CITY OF LA VISTA
MAYOR AND CITY COUNCIL REPORT
MAY 17, 2022 AGENDA

Subject:	Type:	Submitted By:
PUD SITE PLAN AMENDMENT – LOTS 23-26 SOUTHPORT WEST AND A PORTION OF LOT 1 SOUTHPORT WEST REPLAT 4	◆ RESOLUTION ORDINANCE RECEIVE/FILE	CHRISTOPHER SOLBERG DEPUTY COMMUNITY DEVELOPMENT DIRECTOR

RE: Planned Unit Development Amendment – Initial Review Letter
Lots 23-26 Southport West and Lot 1 Southport West Replat Four

Comment Response: PUD Southport West -Letter dated 4/06/22

LA VISTA, NE		CONCEPTUAL PUD PHASING PLAN	
		PUD PLANS	
		SOUTHPORT WEST REPLAT NINE PUD	
		PHASE 1	
		2022	
		REVISIONS	
REV. NO.	DATE	REVISION DESCRIPTION

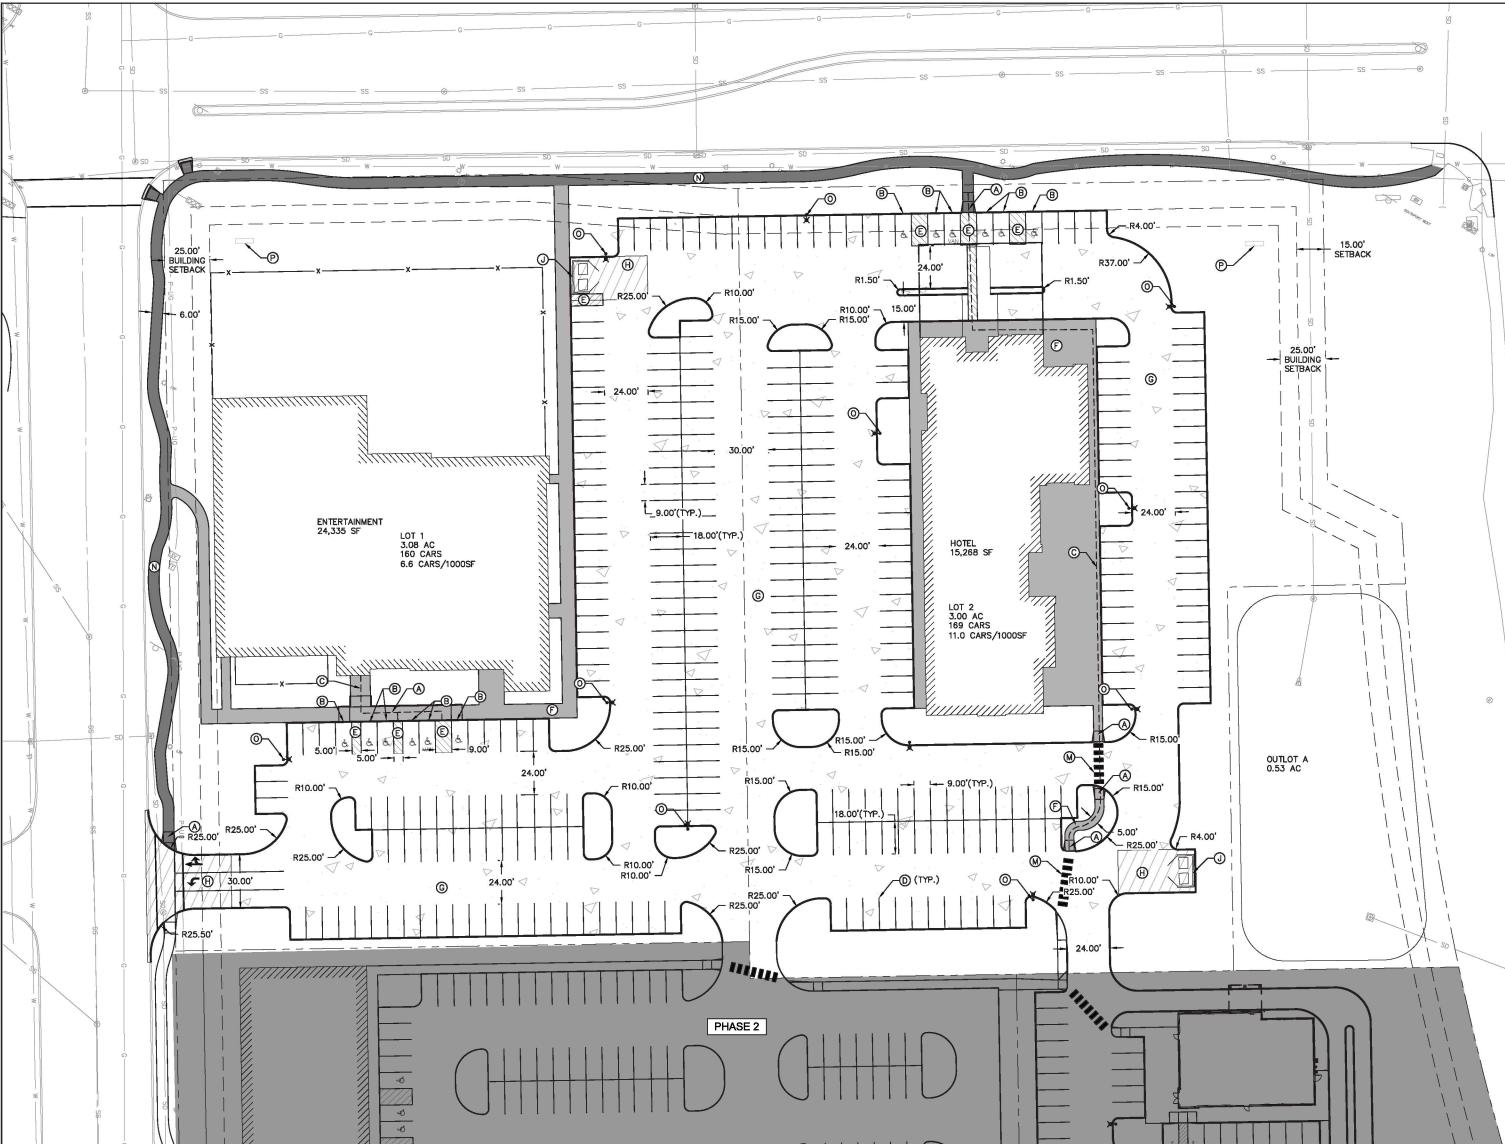
1. As discussed in the pre-application meeting, in an effort to push the northern two lots through the process as quickly as possible, the PUD plan set should concentrate on only the development of the northern two lots. Except for sheet C3.0, the PUD plan set should not include the site design below the southern lot line of lots 2 and 3.

Please revise the title of sheet C3.0 to "Conceptual PUD Phasing Plan" and change the phasing to only include lots 2 and 3 in Phase 1.

Response: Per discussions, the plans have been revised to reflect the design for the north 2 lots only and phasing clarification has been updated accordingly.

SHEET
C4.1

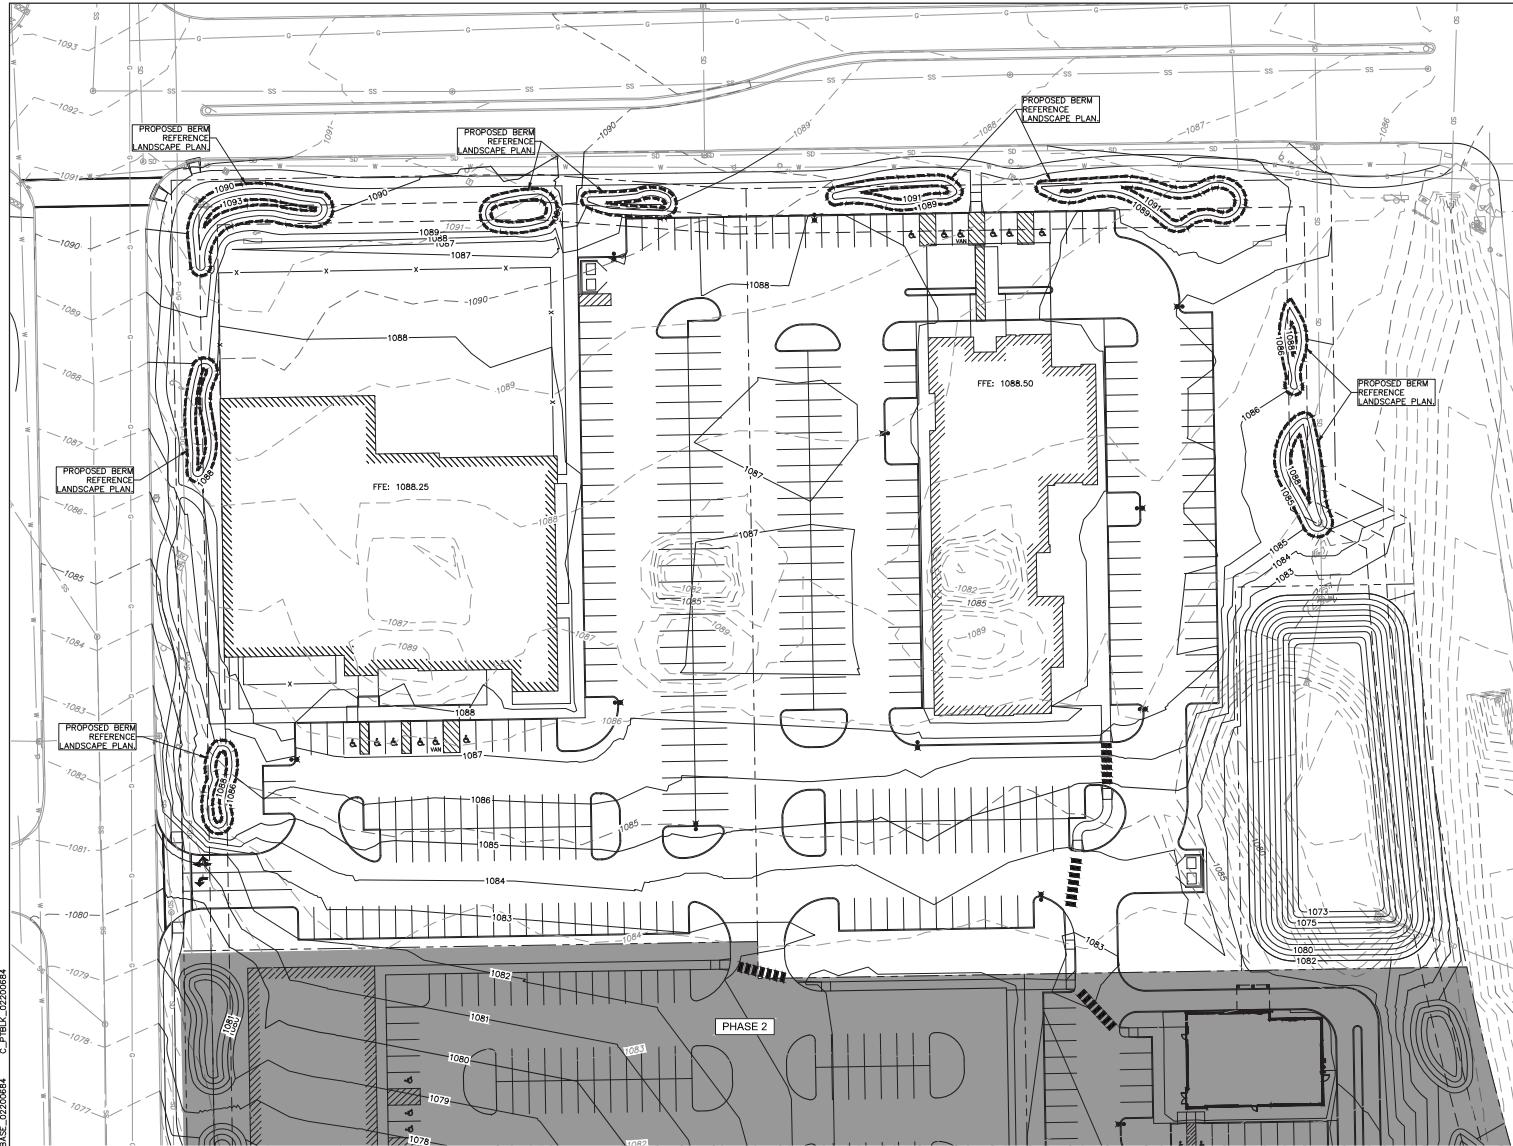
11. Sidewalk connections to buildings on lots 1, 2, and 4 need to be added for safe pedestrian connections to these developments, per Section 5.15.04.15.

17. The PUD Site Plan does not depict the locations of any proposed monument signage. Please provide proposed locations of this signage to ensure conformance with the zoning regulations.

Response: Sidewalk connections have been added.

Response: Future monument sign locations have been shown and will be finalized with the end users.

SHEET	LA VISTA, NE	EMERGENCY VEHICLE ACCESS PLAN PUD PLANS			REVISIONS	olsson
		REV. NO.	DATE	REVISIONS DESCRIPTION		
	SOUTHPORT WEST REPLAT NINE PUD PHASE 1				2022

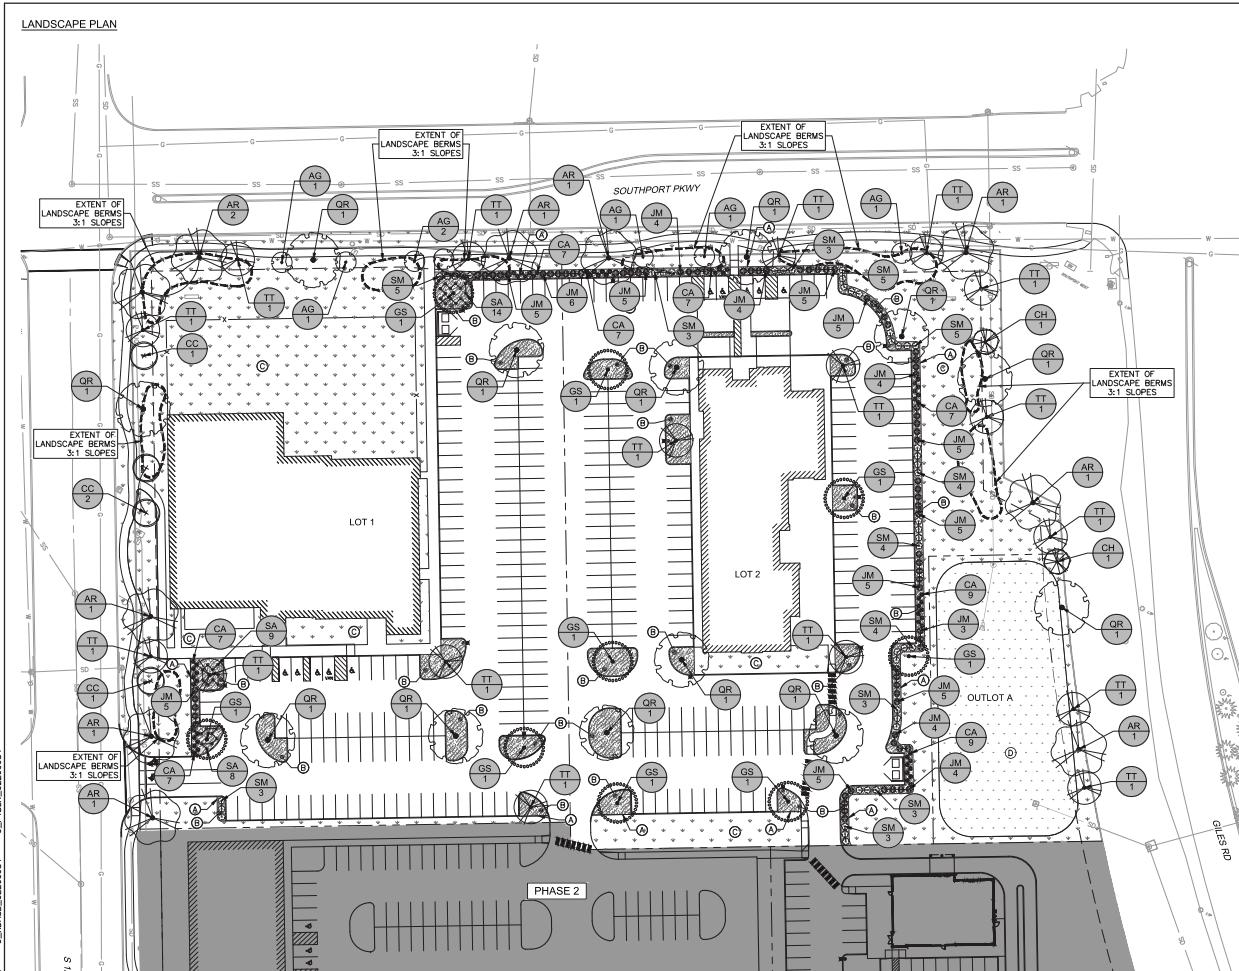
1. The Emergency Vehicle Access Plan does not adequately depict how the hotel on Lot 2 will be accessed.

Response: This has been revised to show the path through the hotel site.
